REV. NO.	DESCRIPTION	DATE
1	ADDENDUM 3 - REMOVED PROP. MOTOR OR VALVE ACTUATOR REVISIONS	FEB 2023

CORTEZ BOOSTER PUMP STATION UPGRADES

CIVIL
PROPOSED SITE PLANS

HORIZONTAL: **M-3**

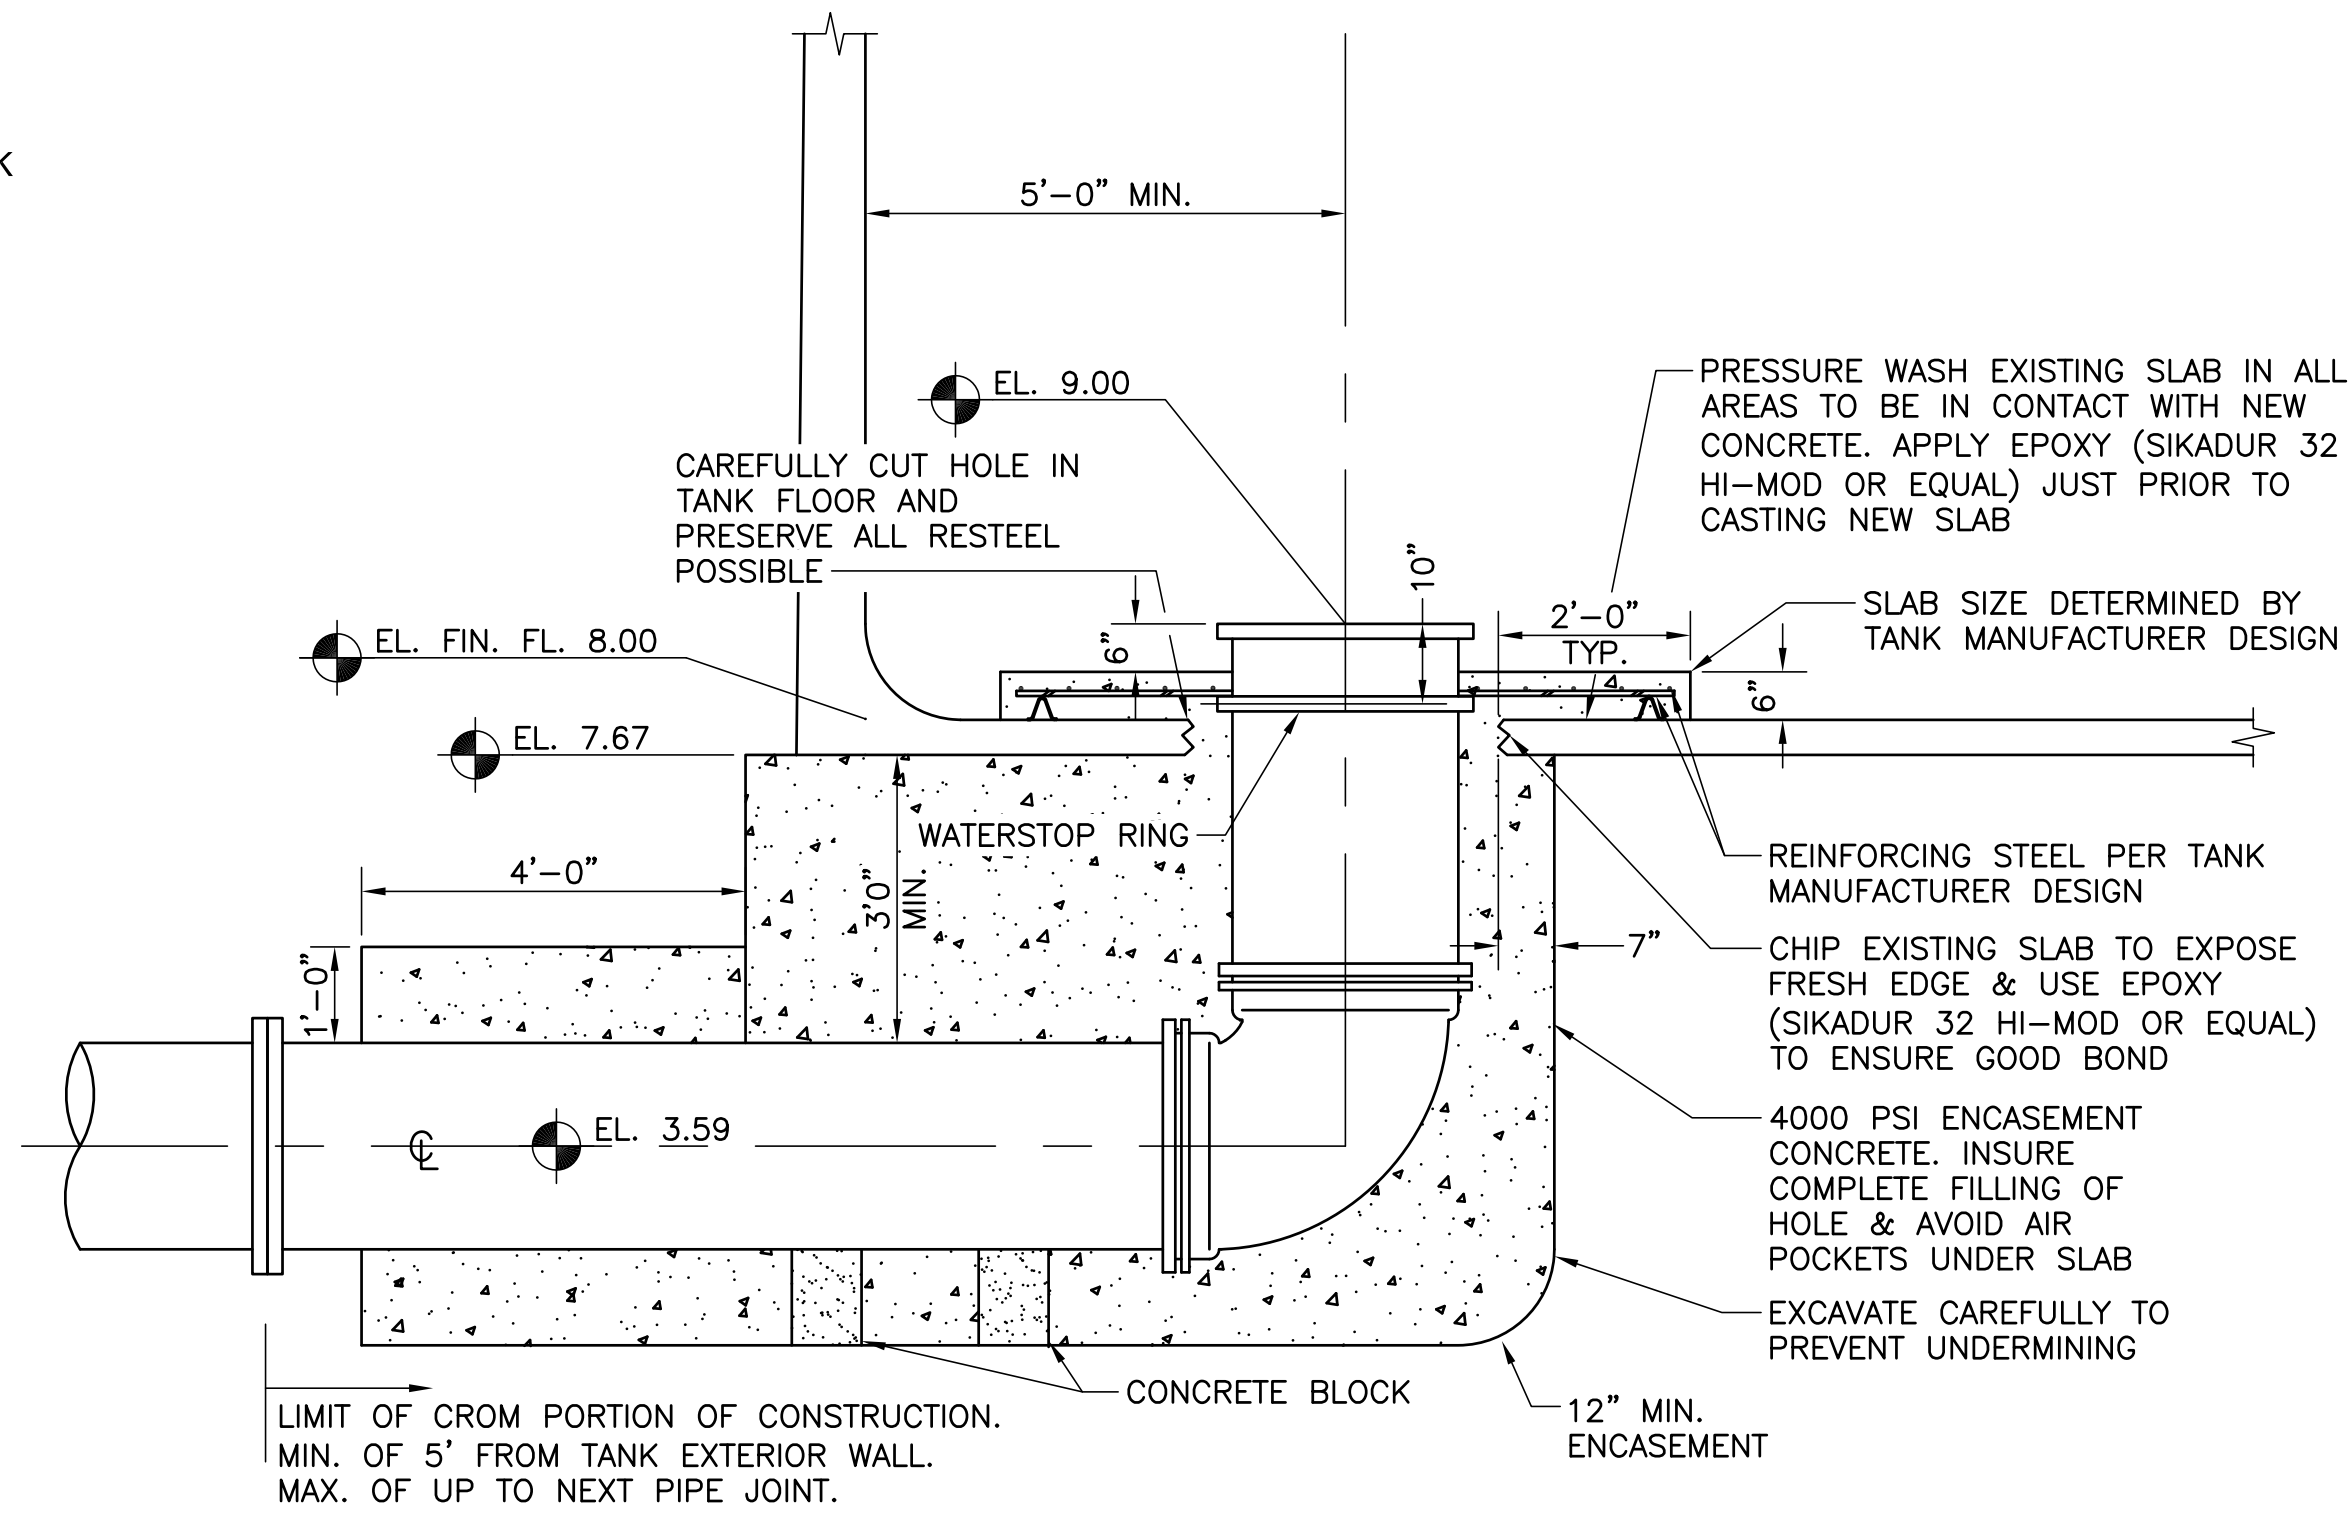
REV. NO.	DESCRIPTION	DATE
1	ADDENDUM 3 - REMOVED PROP. MOTOR OP. VALVE ACTUATOR	FEB 2023
